Application ref: EN010147

Application by Photovolt Development Partners (PVDP) on behalf of SolarFive Ltd (the Applicant) for a Development Consent Order for Botley West Solar Farm

Notification of Intention to Submit a Request to Change the Application (Change Request 2)

Change Request 2
Notification - Change 1

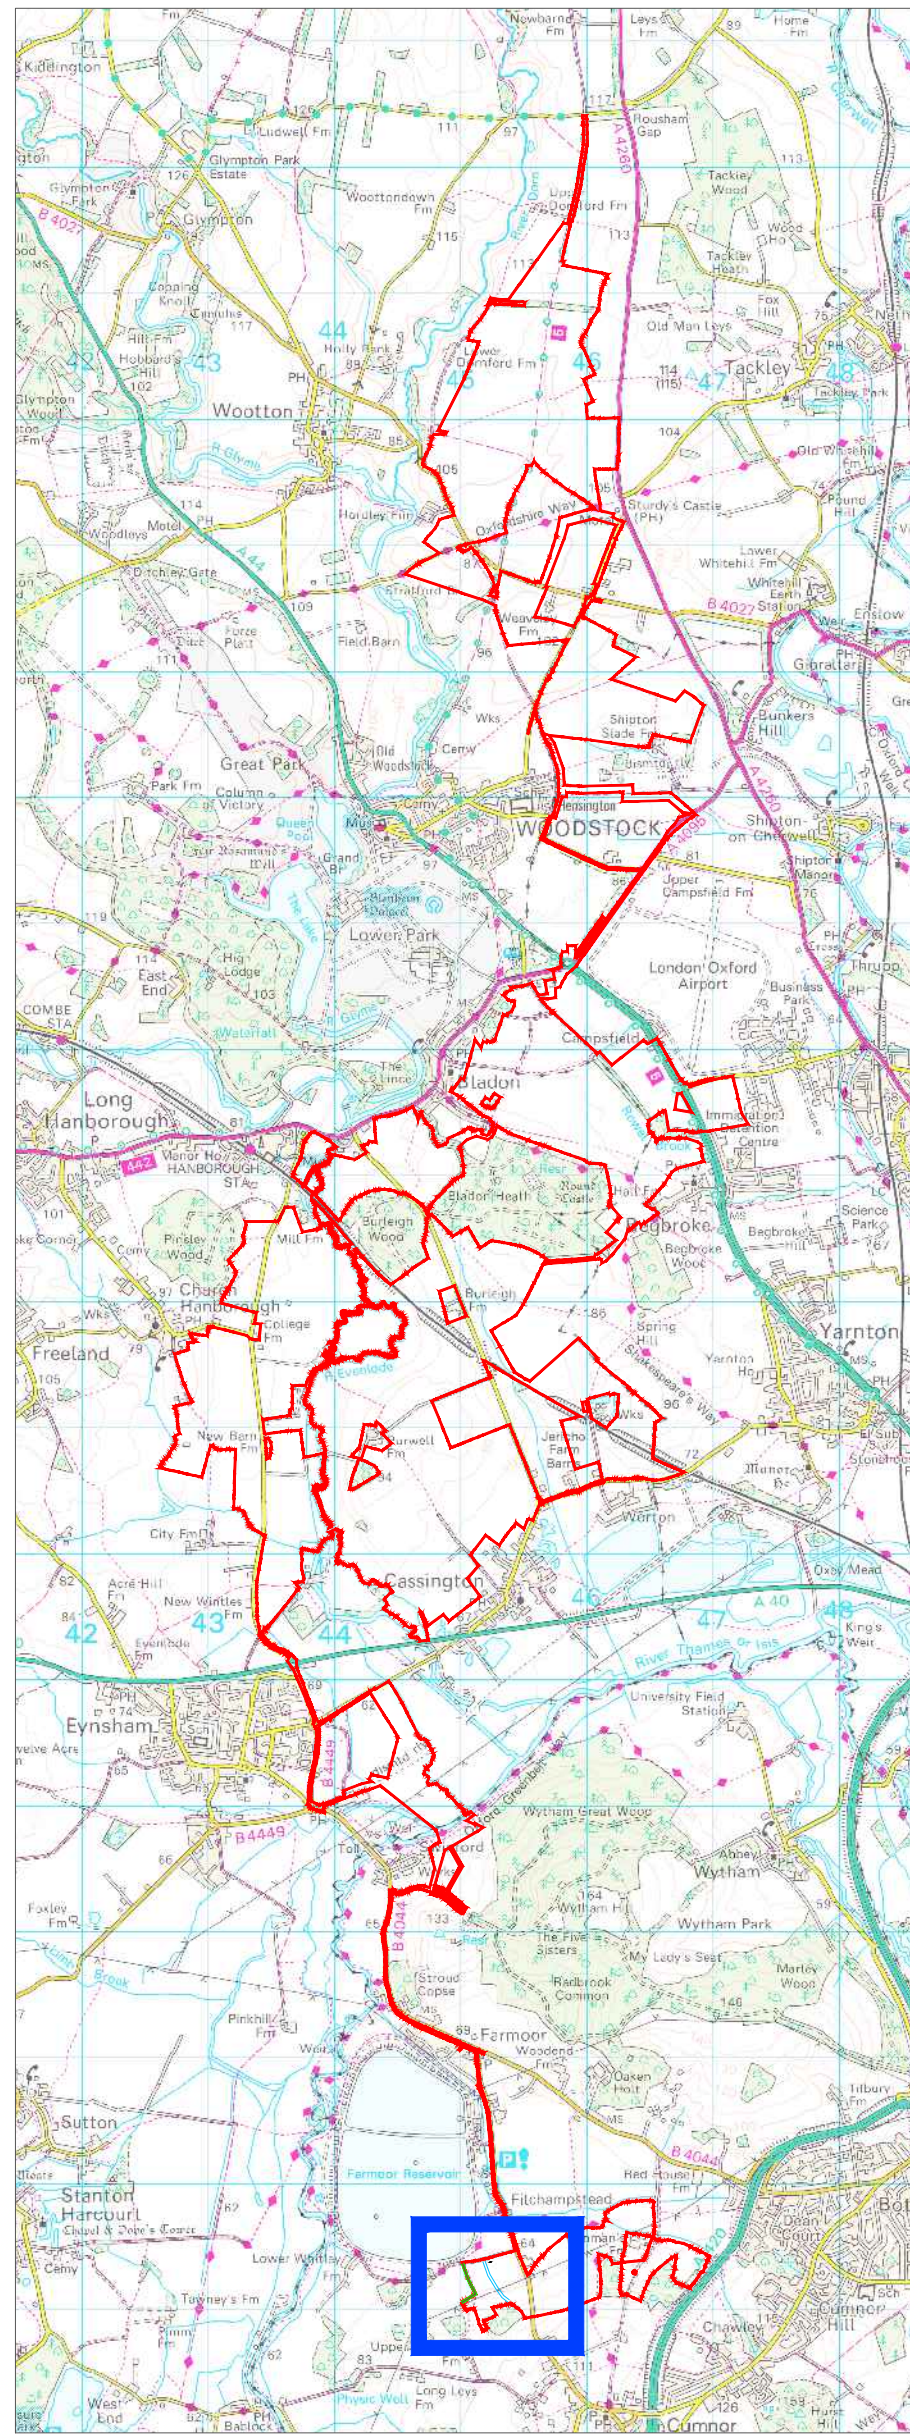
Change 1: Reduction in Order Limits boundary to reduce the solar installation area south-west of Bladon and removal of solar arrays on land south-east of Bladon and north of Heath Lane (see Appendix A attached to the Notification)

- 1) To the south-west of Bladon it is proposed to reduce the Order Limits by approximately 31ha, involving the removal of a solar installation area of approximately 25ha, along

with associated maintenance roads, fences and gates. The 275Kv cable corridor route option remains along the southern edge of this location. The remaining land is to be removed from the Order Limits and will continue in agricultural use by the landowner; and

- 2) To the south-east of the main settlement at Bladon, east of Grove Road and north of Heath Lane, the Applicant proposes the removal of a further solar installation area of approximately 17.6ha, along with associated maintenance roads, fences and gates. The Order Limits is not proposed to be amended in this area and the land will be retained within the Order Limits. Whilst the solar array and associated infrastructure is proposed to be removed, the resultant freed up area of land will be retained for meadow grazing, contributing further to the Projects biodiversity net gain (BNG). The community food growing and educational areas, together with the upgrading of the right of way that crosses this area would remain as part of the Project.

(1) (2) Replace solar installation area, fence, maintenance roads and gates for further visual protection (Total: 42.3ha)

(3) Reduction in redline (31 ha)

Title: Change Request 2
Notification - Change 3

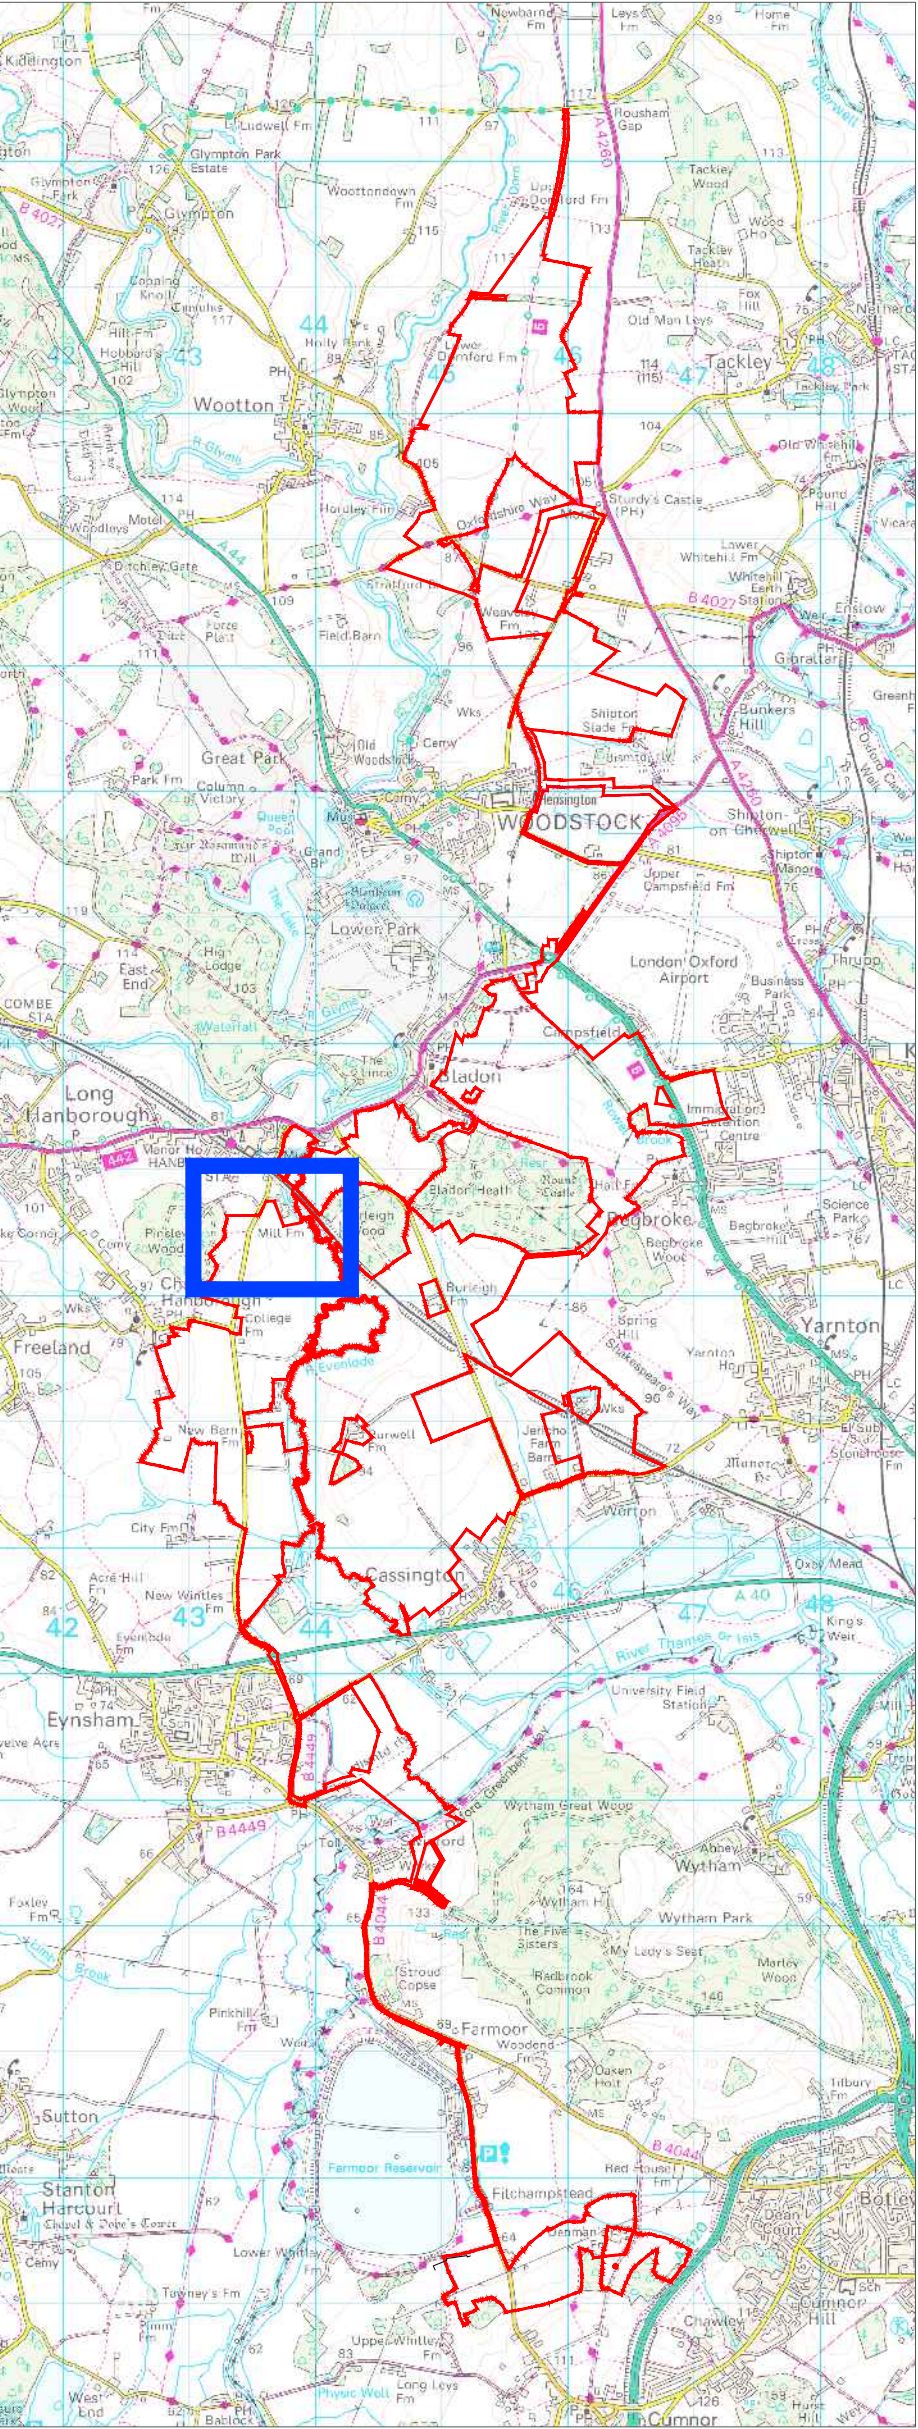
Change 3: Refinement of Project layout and design to reposition the main Project substation as shown on Sheet 13b of the Works Plans [AS-005] (see Appendix A attached to the Notification)

However, the Applicant is proposing to adjust the layout shown on Sheet 13b such that the Project main substation would be moved to the western side of the land parcel within the Order Limits, closer to where the new National Grid substation is proposed to be relocated. The additional solar array would then be to the eastern side of the land parcel shown on Sheet 13b. This would allow for a shorter, more efficient and more cost-effective cable connection to the National Grid substation. This was recognised by the ExA in the Issue Specific Hearing 1 (on DCO and Strategic Matters) and the Applicant is seeking this change partly in response to that suggestion.

Notification - Change 4

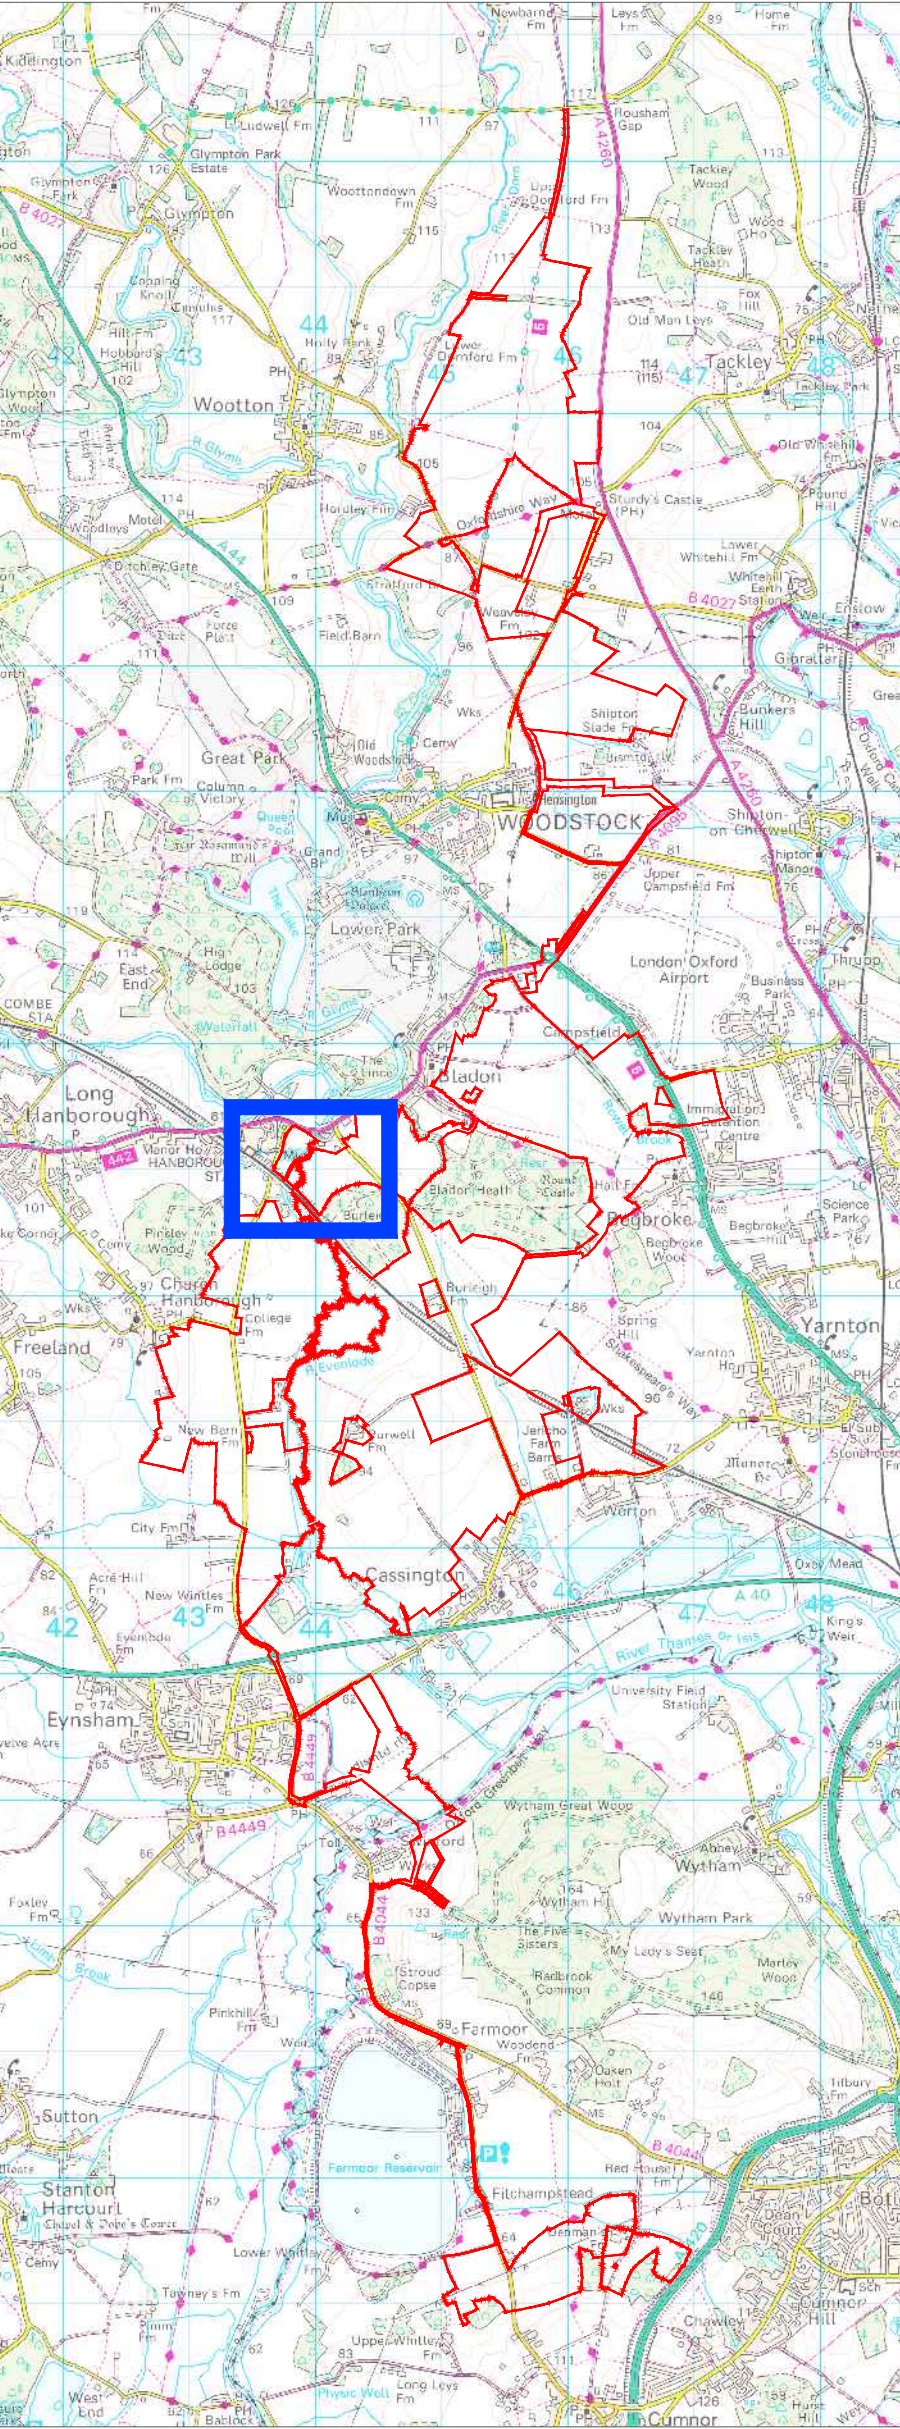
Change 4: Refinement of Project layout and design to reduce solar installation on land east of Lower Road (see Appendix A attached to the Notification)

The Applicant is aware of a restrictive covenant which prevents the construction of 'buildings' over Plots 6-18, 6-19, 8-06, 8-07, 8-13, 8-14, 8-15, 8-16, on which the Applicant proposes solar arrays and related infrastructure. In any event, the draft DCO would facilitate the extinguishment of that restrictive covenant to allow the development to proceed. Notwithstanding, the Applicant has continued to engage with the affected landowner to try and find a reasonable alternative proposal. To date, the IP has maintained his position that he does not want solar installation over the relevant land parcel. The Applicant is therefore proposing to reduce its powers of solar installation over a large part of the affected land, specifically immediately to the west and south of the IP's property. This would result in a loss

(1) Remove solar installation area, fence, maintenance roads and gates (2.7ha)

(2) New hedgerow proposed (730m)

(3) Indicative 33 kV Cable Route removed

Title: Change Request 2
Notification - Change 5

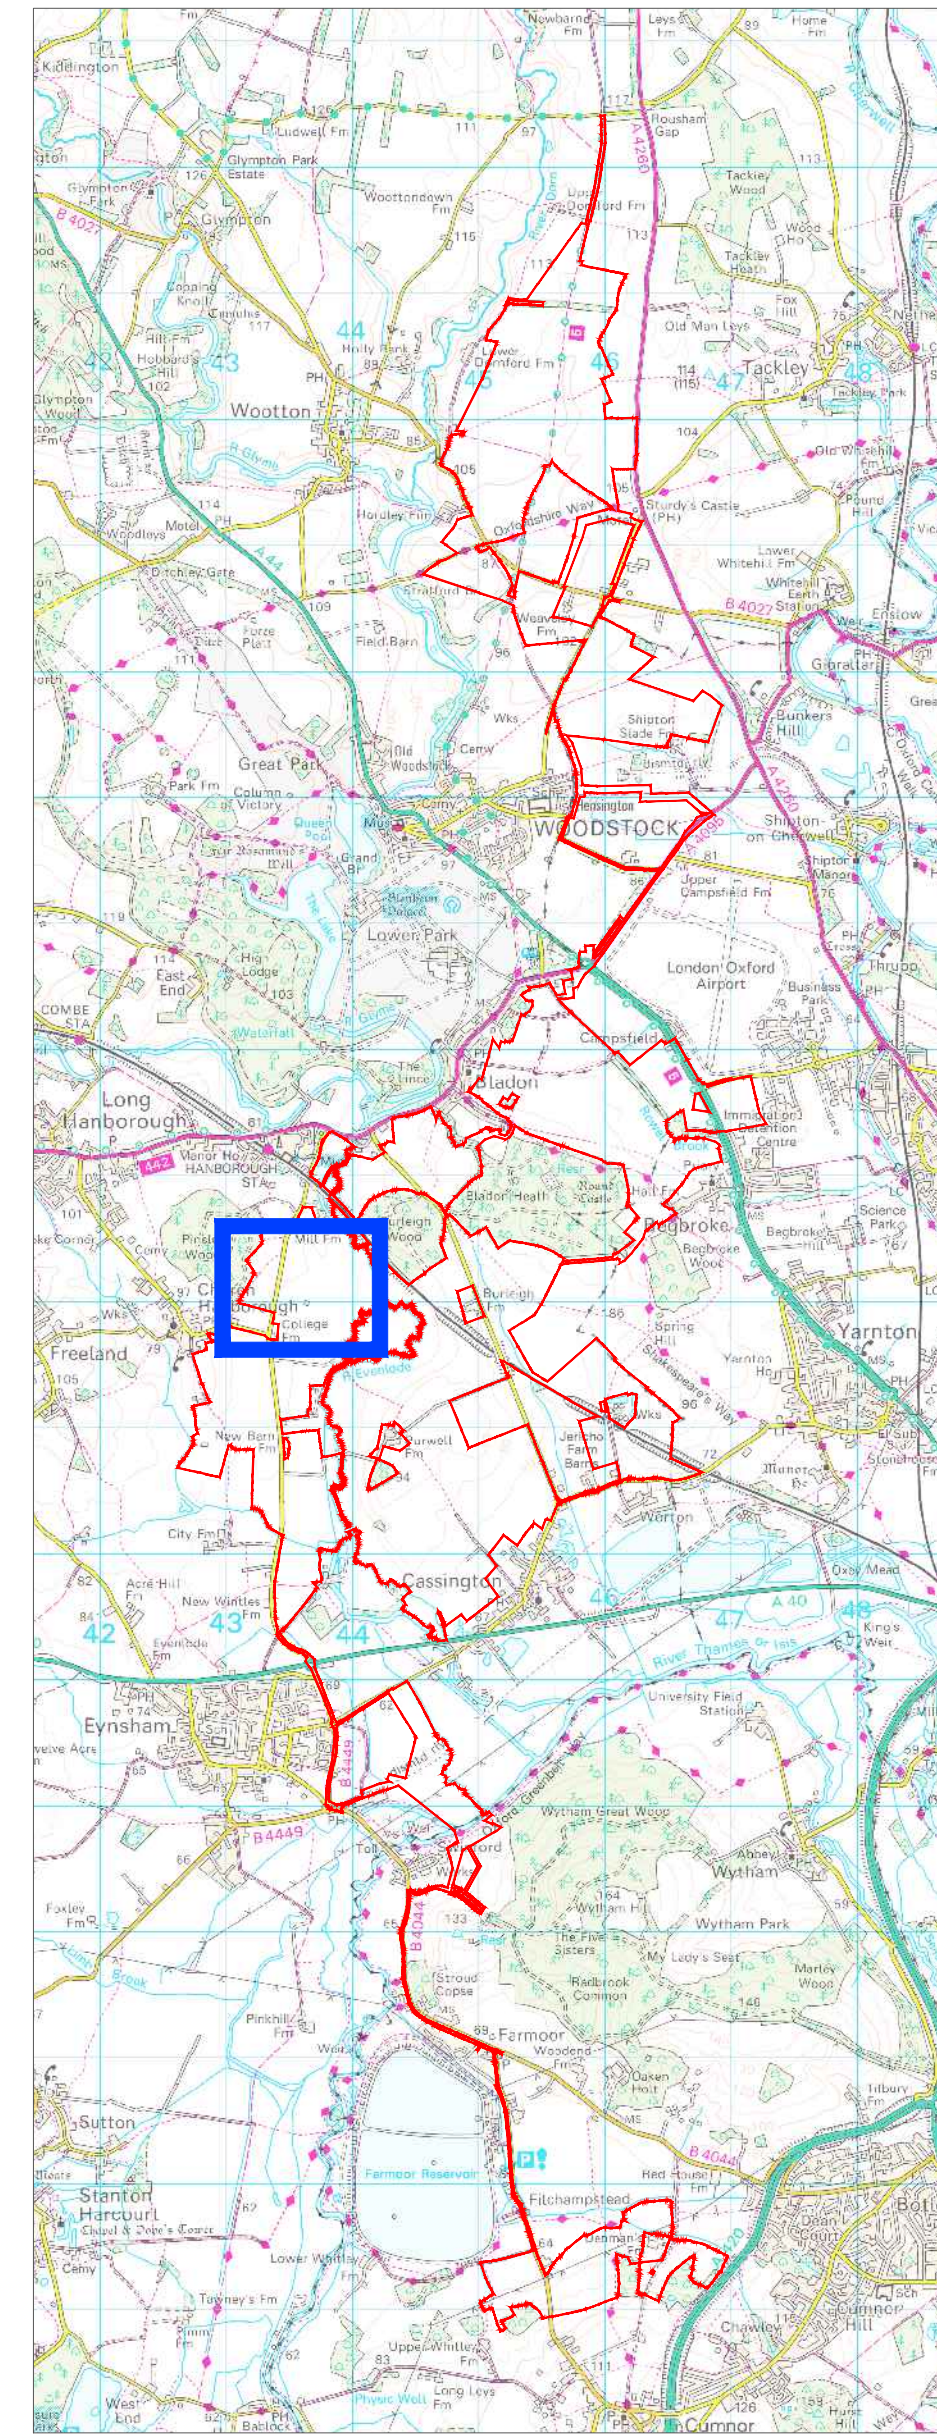
Change 5: Refinement of Project layout and design to remove installation areas overlapping with Flood Zones 2 and 3 (see Appendix A attached to the Notification)

As a result of a base mapping error, the Applicant has identified minor anomalies where the solar installation slightly overlaps with Flood Zone 2 or 3 throughout the Project site. The Applicant is committed to not develop within Flood Zone 2 or 3 and so is proposing to correct this mapping anomaly. This has resulted in a small loss of installation area in several locations amounting to approximately 0.72 ha.
